SERVICE BULLETIN

MERCURY OUTBOARDS

Number: 79-1

- A. Merc 700 and 800 Mid-Range Bogging
- B. Timing - 1979 Merc V6 Outboards

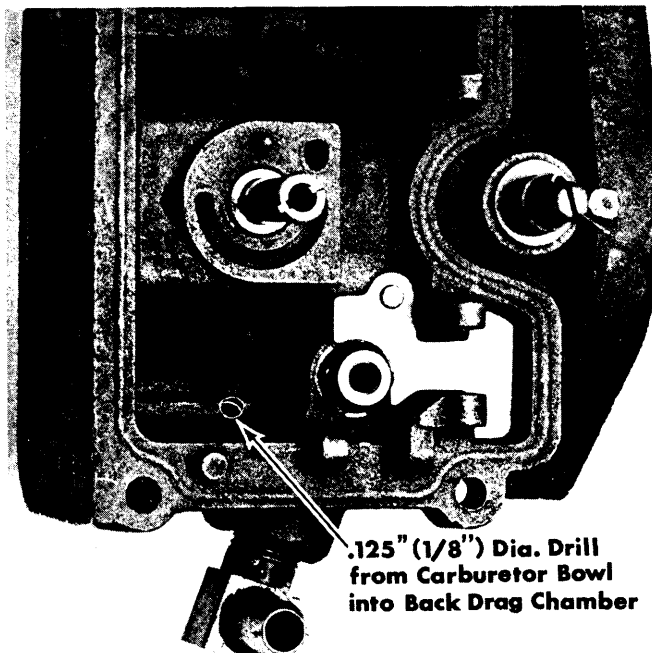
*S/N 494 & below
do not have new style
seats.*

Numerous complaints have been received regarding mid-range bogging on Merc 700 and 800 models, particularly when water skiing.

Most complaints of this type have been corrected (on the Merc 700 only) by installing the A-1399-7280 inlet seats, as explained in Service Bulletin No. 78-2, Item C, dated 10/25/77. If this remedy does not correct the problem, however, a $\frac{1}{8}$ " (.125" or 3.2mm) diameter hole can be drilled into the carburetor body, as shown in the illustration on the right.

It will be necessary to remove the float bowl cover and floats to drill the hole. Be certain to remove all aluminum chips before reassembling the carburetor.
